# Service Information

HD4504 HD4505  
HD4506 HD4700

DAP132

## Domestic Appliances and Personal Care

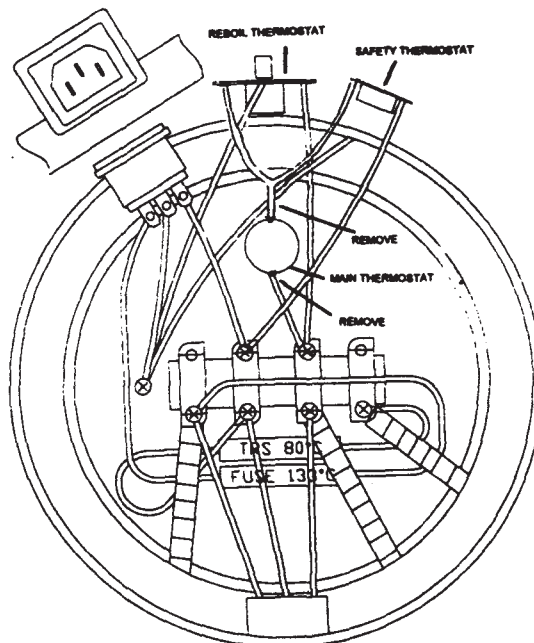
In high altitude area, water may found boiling continually without changing to keep warm mode. In this case it is advised to change the main thermostat ( Item 13 in service manual ) temperature rating from 90°C to 85°C. The new thermostat order number is 4822 282 10302.

After changing the main thermostat, stick a "High altitude area use" label to the bottom plate for differentiation.

To replace main thermostat ( Item 13 ) :-

- 1) Remove base plate.
- 2) Disconnect the two wires from main thermostat.

- 3) Remove main thermostat.
- 4) Fit a 85°C temperature rating thermostat in position, make sure the contact surface are even, reconnect the two wires.
